COUNCIL SUPPLEMENTARY REPORT

Panel Reference	PPSSNH – 191
DA Number	DA 19/21
LGA	North Sydney
Proposed Development	Demolition of all existing buildings and works, and construction of a commercial building with 57 levels above ground (including plant) and a basement of 7 levels.
Street Address	110-122 Walker Street North Sydney
Applicant	Stockland Development Pty Ltd C/- Urbis Pty Ltd
Owner	The Trust Company Limited
Date of DA lodgement	22 January 2021, original application, 12 August 2021, first amendment, 19 January 2023, second amendment, XX April 2022, third amendment
Number of Submissions	51
Recommendation	Approval
Regional Development Criteria	Capital Investment Value (CIV) greater than \$30 million (\$498,630,000.00)
List of all relevant s4.15(1) matters	<ul style="list-style-type: none"> • North Sydney LEP 2013 • North Sydney DCP 2013 • SEPP (Transport & Infrastructure) 2021 • SEPP (Biodiversity & Conservation) 2021 • SEPP (Resilience & Hazards) 2021

Figure 1: Site, yellow outline, and 1 Denison St, the location of the Channel 9 facilities, green marker (Near Map image 3 April 2022).

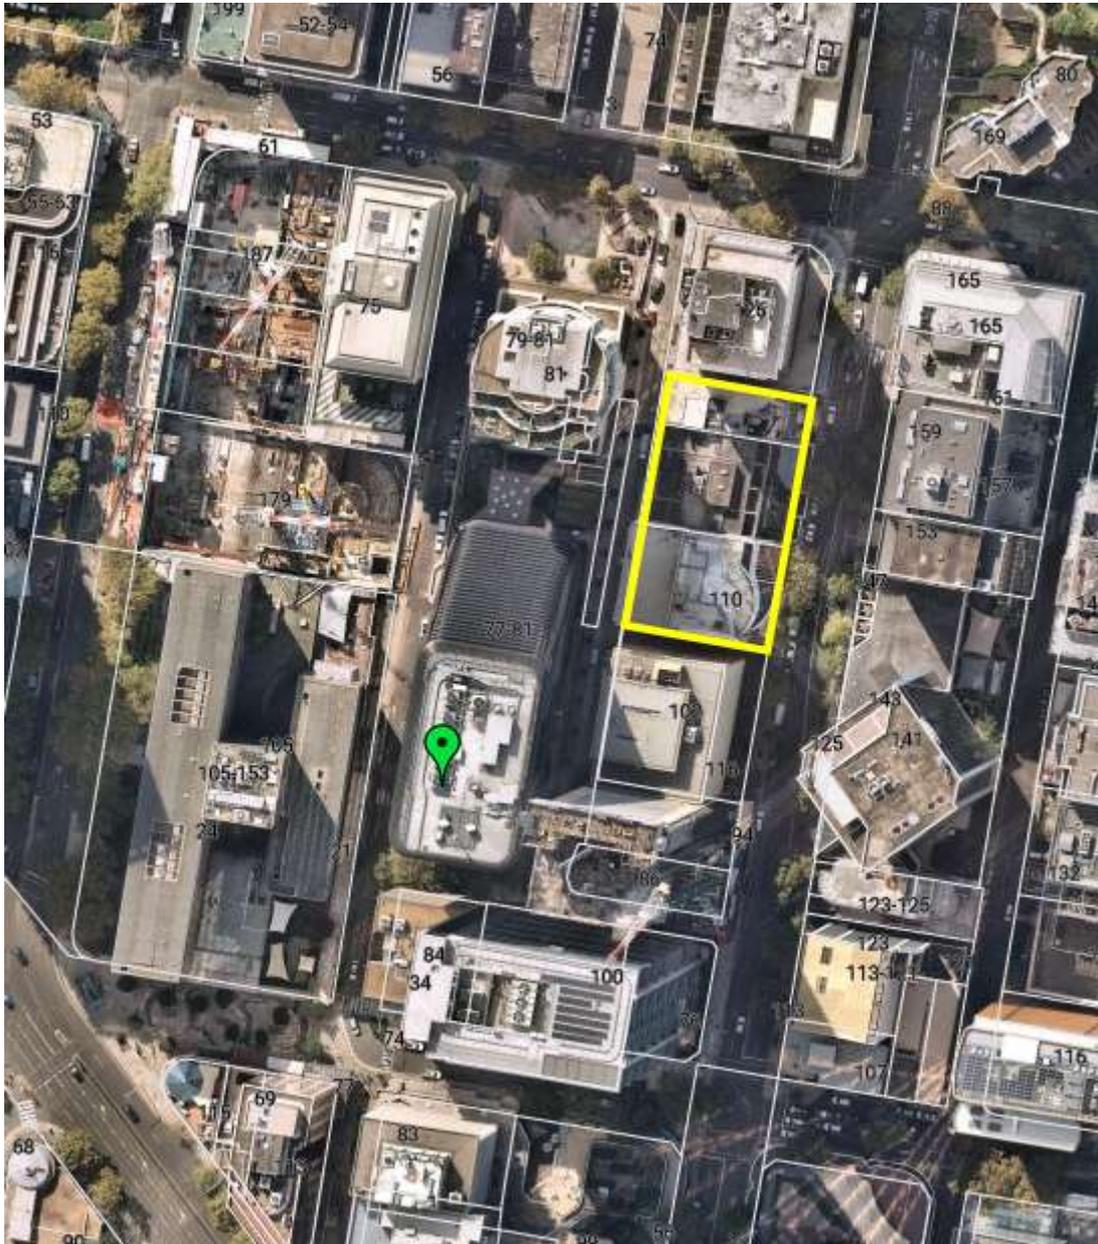
The broadcaster has objected to the application, indicating their transmission of television signals between an antenna on the roof of 1 Denison and a facility at Frenchs Forest could be blocked by the proposed building. A direct line of sight between these facilities is essential to the broadcast operations of the submitter's network, the submission states.

A letter from Stockland to Channel 9 included information which demonstrates the proposed development will not interfere with Channel 9's television broadcasting.

Channel 9 consequently withdrew their objection, provided a condition is included in the approval to enable ongoing consultation between them and the applicant, to ensure construction activities and equipment (cranes) do not restrict or prevent broadcast operations. The applicant is prepared to have such a condition included, and one is accordingly recommended.
